DSP-15020-03

Application	General Data	
Project Name: Capital Plaza, Eastern Pad Sites Location: On the north side of MD 450 (Annapolis Road), approximately 1,000 feet east of its intersection with MD 295 (Baltimore-Washington Parkway). Applicant/Address: Capital Plaza Associates Ltd. Partnership 7811 Montrose Road, Suite 420 Potomac, MD 20854 Property Owner: Same as applicant	Planning Board Hearing Date:	07/19/18
	Staff Report Date:	07/16/18
	Date Accepted:	05/16/18
	Planning Board Action Limit:	07/25/18
	Plan Acreage:	43.81/3.80
	Zone:	C-S-C/D-D-O
	Dwelling Units:	N/A
	Gross Floor Area Proposed:	24,840 sq. ft.
	Planning Area:	69
	Council District:	03
	Election District	02
	Municipality:	N/A
	200-Scale Base Map:	205NE05

STAFF REPORT

SUBJECT: Detailed Site Plan DSP-15020-03
Capital Plaza, Eastern Pad Sites

PROJECT: CAPITAL PLAZA BUILDING B

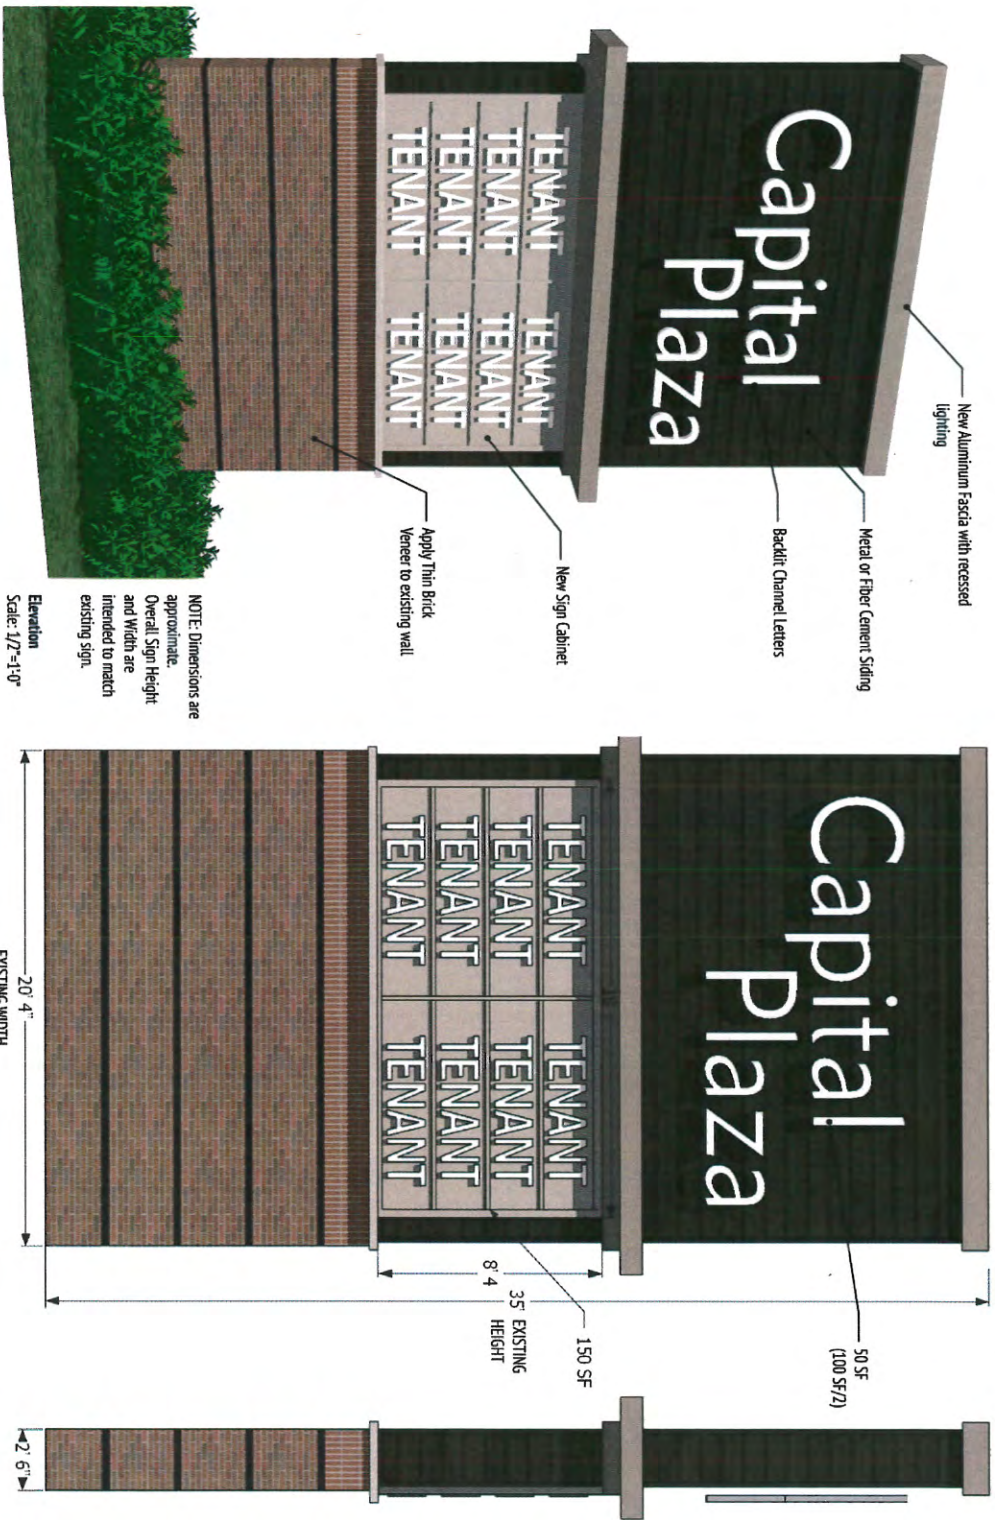
The proposed building elevations show mounted sign placements on the buildings for future tenants, however; the application included directional signs and a menu board with specifications for a Starbucks.

Staff Comment: The applicant should provide details of the materials and specifications of sign to be mounted on the building designated for the Starbucks.
